Issue 1

1948-49 "60" and "75"
1950 "75"
1948-50 LAND-ROVER

ENGINE

EXCESSIVE OIL CONSUMPTION

Fig. 1. Piston modification

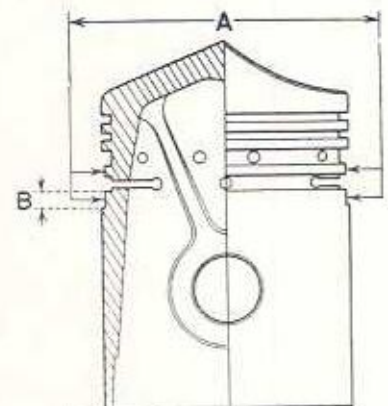
Remove the pistons and modify them by reducing the bottom land and top of the skirt as shown at Fig. 1.

A—Reduce diameter to 2.676 in.—.004 (68 mm.—0.10) for "60" and Land-Rover or 2.506 in.—.004(63, 6mm.—0.10) for "75".

B— $\frac{3}{8}$ in. (4.8 mm.)

The piston clearance across the thrust faces at the bottom of the skirt should be checked as described below; if the clearance does not greatly exceed .0025 in. (0.065 mm.) the original pistons may be replaced with new rings. Otherwise, new modified piston assemblies should be fitted to achieve this clearance.
